**RE: LNAPL CONTAINMENT INTERIM MEASURE WORK PLAN
BULK FUELS FACILITY SPILL
KIRTLAND AIR FORCE BASE
EPA ID# NM9570024423, HWB-KAFB-10-037**

The New Mexico Environment Department (NMED) received on December 1, 2010 the *Light Non-Aqueous Phase Liquid (LNAPL) Containment Interim Measure Work Plan* for Kirtland Air Force Base's (KAFB, or the Permittee) Bulk Fuels Facility Spill (Solid Waste Management Units (SWMUs) ST-106 and SS-111), dated November 2010, hereafter referred to as the Work Plan. In NMED's letter of April 2, 2010, the Permittee was directed to propose interim measures to stop the migration of the light nonaqueous phase liquid (LNAPL, or NAPL) plume and complete remediation of the plume within five years. The Work Plan has merit in that it presents a conceptual design for a pump-and-treat system to arrest migration of the LNAPL plume. Even though it does not have as a primary objective clean up of the bulk of the LNAPL that has been released, if successful, it could provide interim protection to allow for more time to develop and implement other remedial alternatives to clean up the vadose zone, LNAPL, and dissolved-phase groundwater contamination.

Figure 1. Locations for Extraction Wells and Injection Well

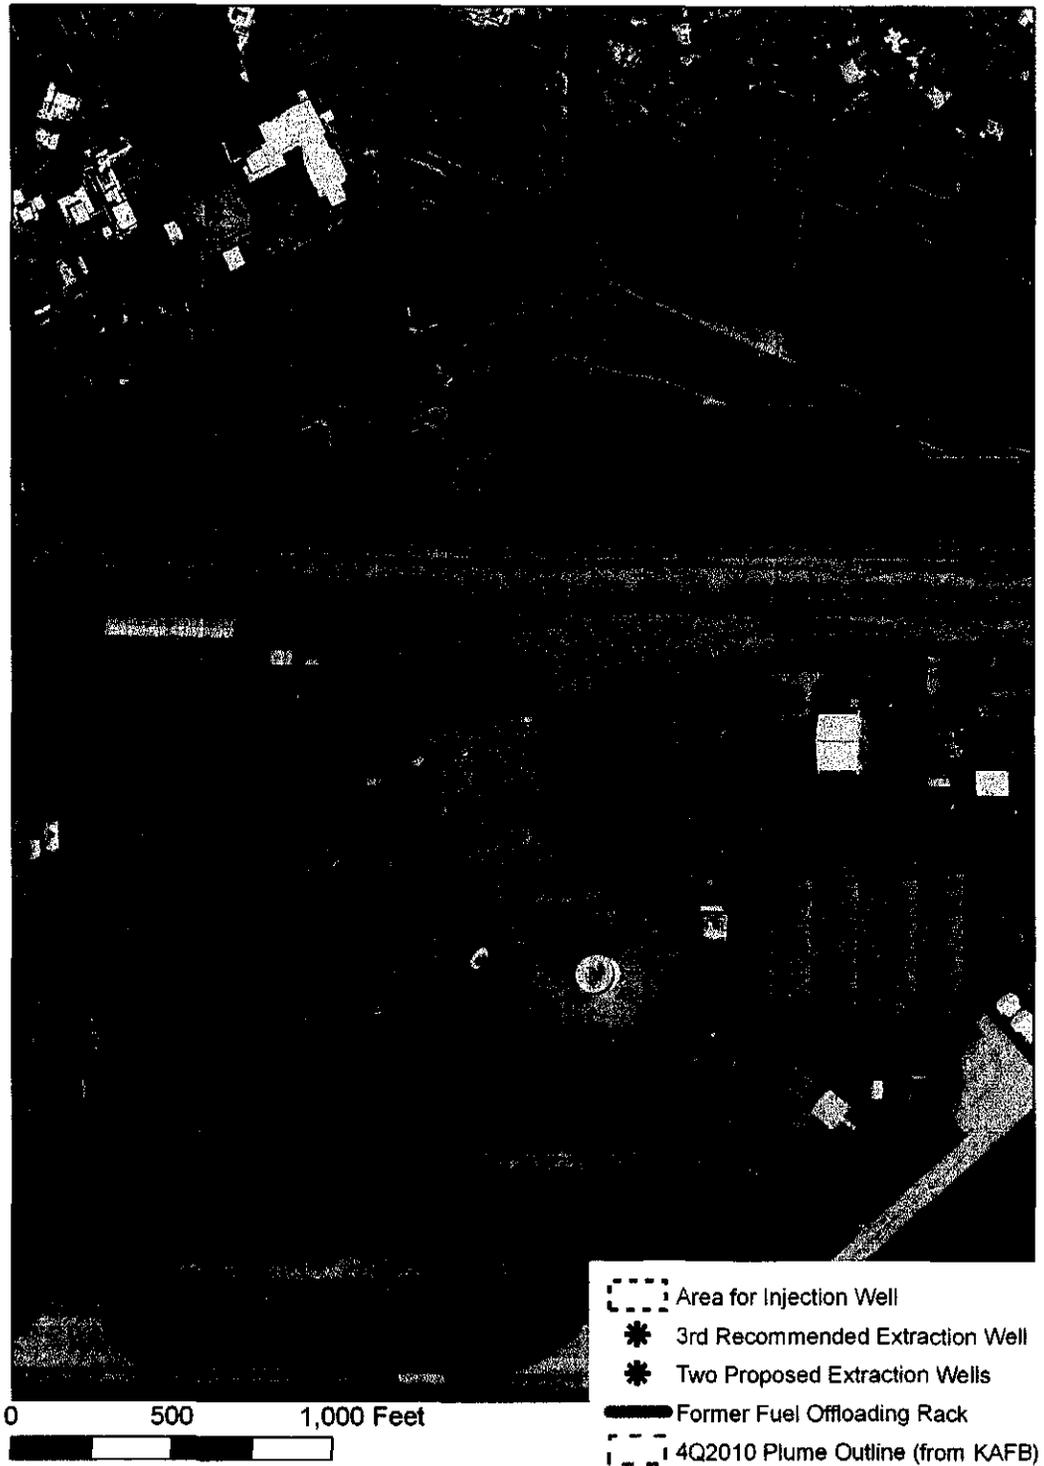
16. The Permittee's analysis indicates that two extraction wells will capture the LNAPL plume, assuming the hydraulic parameters used in the analysis are reasonably accurate. However, there is considerable uncertainty regarding these parameters. The last three bullets of Section 5.1 indicate that a feasibility analysis was performed that resulted in the selection of a two-well hydraulic extraction system. NMED agrees that a system with two vertical extraction wells is better than one vertical well for the reasons described. However, the same logic can be used to validate the efficiency of three vertical extraction wells or more. While the Permittee has demonstrated that one extraction well is inadequate, the optimum number is still in question. The proposed two-well system may in fact not provide adequate capture of the LNAPL plume. At least one additional extraction well should be considered to provide system redundancy, enhance system flexibility, and facilitate monitoring during system performance and pumping tests. The suggested location for the well is midway between proposed wells KAFB-106108-NAPL and KAFB-106109-NAPL (see Figure 1 of this letter).

17. NMED does not approve of a cross-gradient location of the injection well, as specified in Section 6.2 and as shown on Figures 5-1, 5-2, and 6-1 of the Work Plan. This objection was first expressed by the NMED in its public meeting held on January 12, 2011, where representatives of KAFB were present. The injection well must be located upgradient of the LNAPL plume within the area shown on Figure 1 of this letter such that any contaminated water for which treatment fails to achieve clean up goals will be recaptured by the containment system or other future remedial system. The proposed injection well location is not acceptable because detectable levels of contaminants would be introduced into a portion of the aquifer near a water supply well where contamination is not known to exist. Also, this area would not be subject to capture and subsequent treatment, putting the water supply unnecessarily at risk.

This additional extraction well would provide additional benefits, including system back-up for the proposed primary extraction wells during down times, and (if not being pumped) water-level measurements within the capture zone between the active extraction wells. Even if not brought online immediately, it could be activated as a primary extraction in the future well to facilitate adequate capture.

The combination of a pump-and-treat system with an upgradient injection area provides a circulation cell whereby treated water is drawn into the upgradient portions of the plume in the capture zone. This imparts a flushing effect and serves to enhance hydraulic movement of the plume toward the extraction location, which should accelerate cleanup of the LNAPL and dissolved phase plume. NMED acknowledges the Permittee's March 24, 2011 letter and attachment to the Albuquerque Bernalillo County Water Utility Authority (WUA), in which Dr.
